APPROVED MINUTES

May 19, 2011 Standards Committee Meeting

RE: Minutes for the May 19, 2011 Standards Committee Meeting

706-BRPP-04 RAILING, PS-2

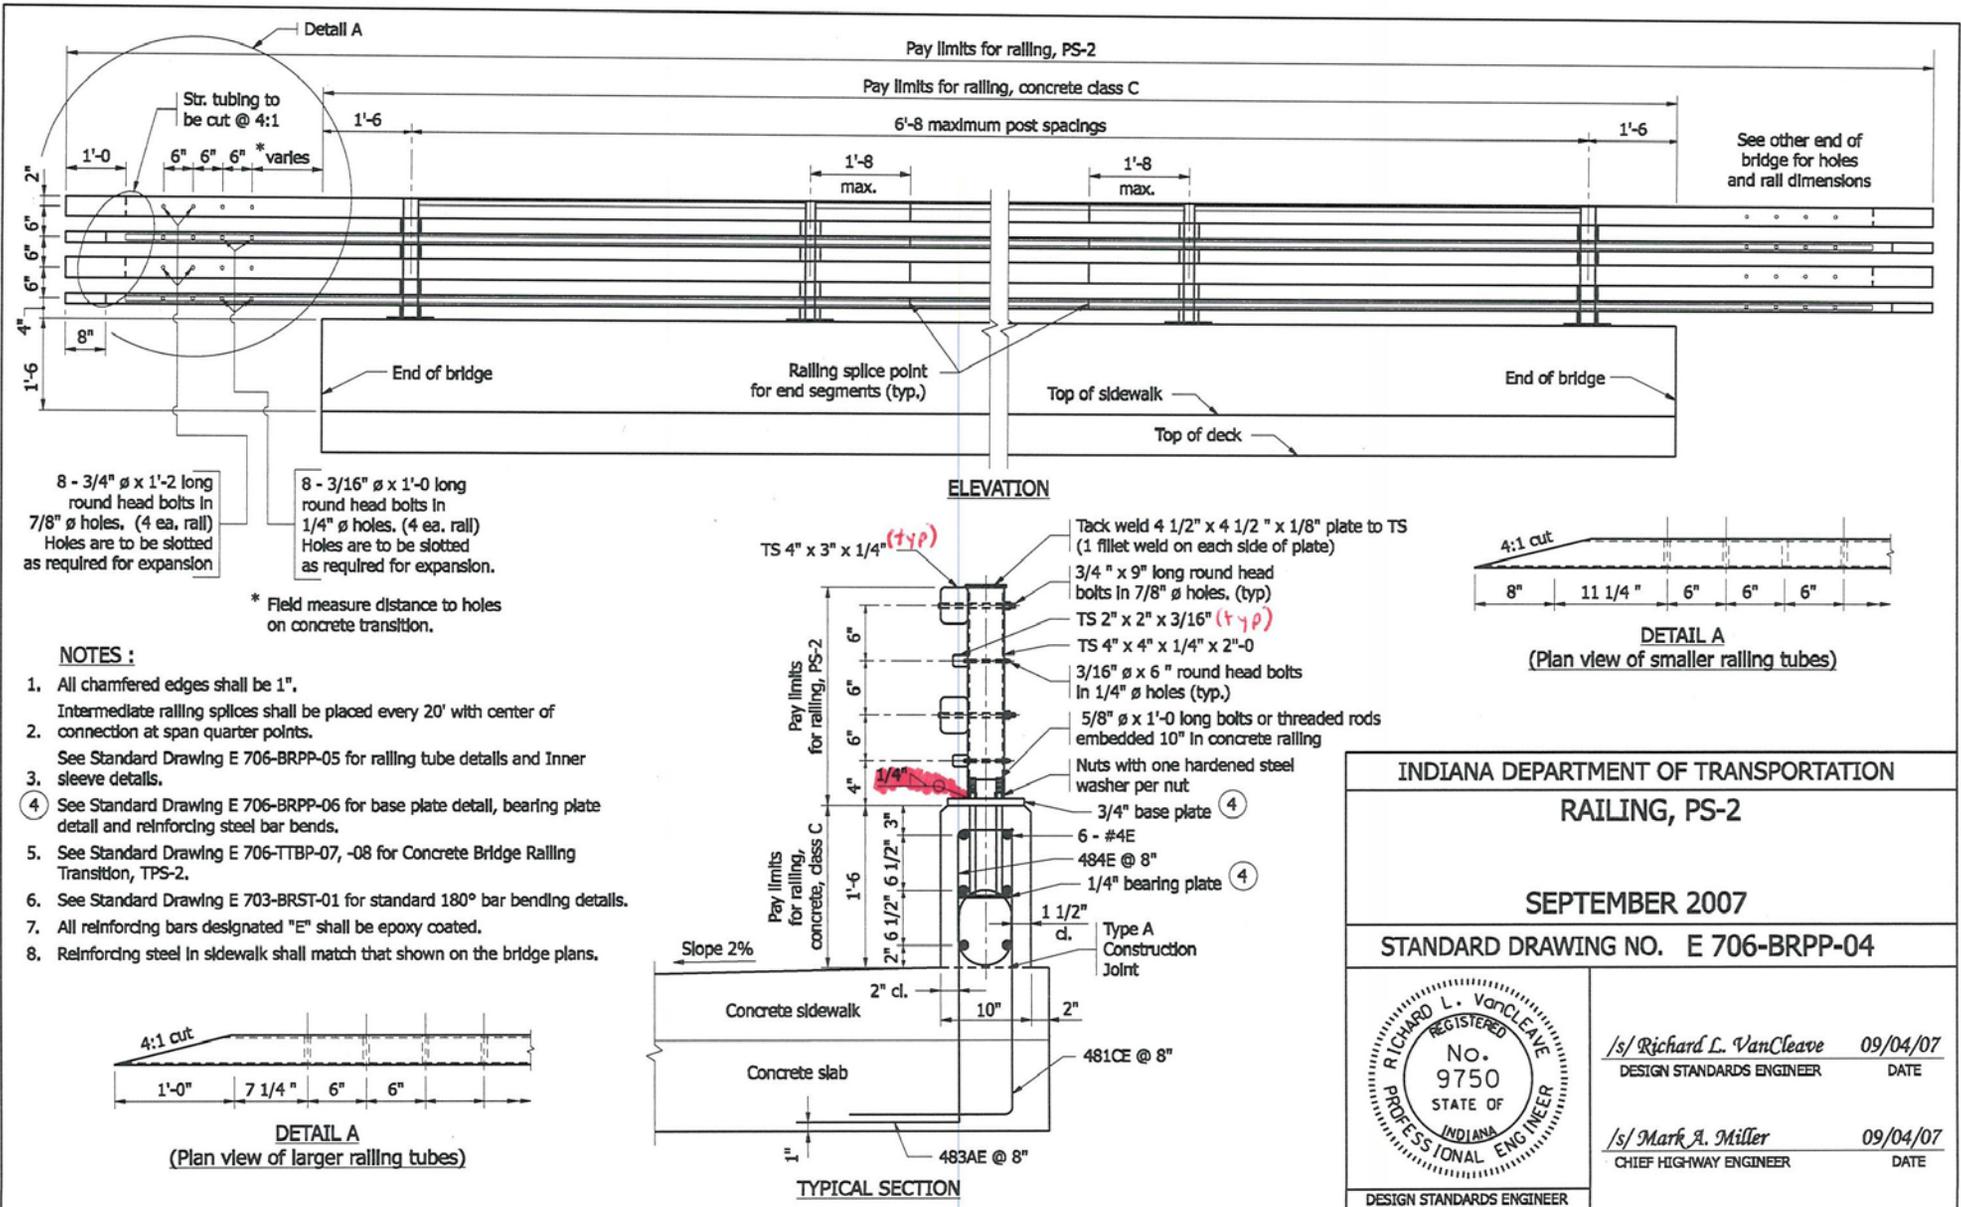
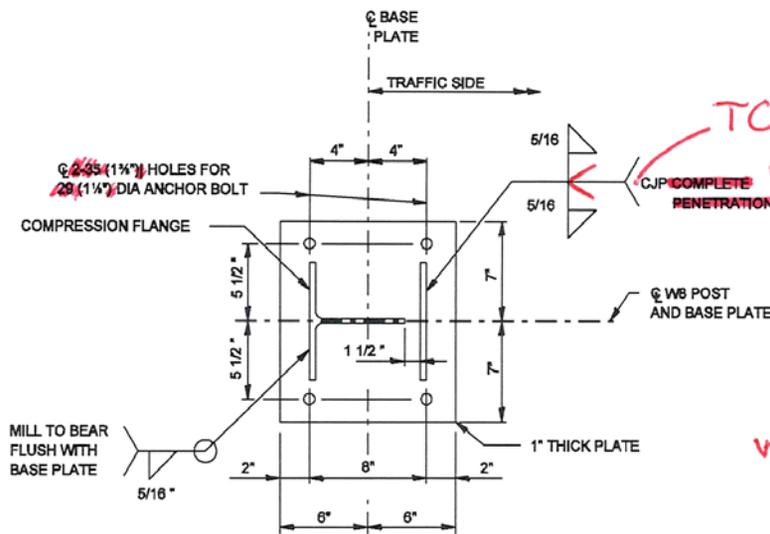
DISCUSSIONS: This item was introduced by Mr. Reilman, who explained that some discrepancies were found in the standard drawings regarding weld symbols and requirements. Further revisions are proposed to provide clarity, and were explained by Mr. Reilman.

PROPOSED SOLUTION: Show the welding requirements where necessary.

706-BRPP-06 RAILING, PF & PS DETAILS

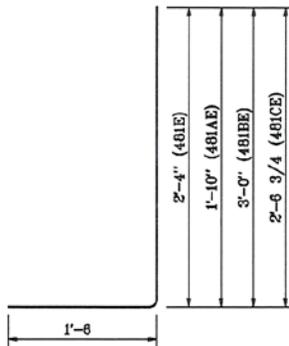
Show holes as slotted, similar to 706-BRTM-02
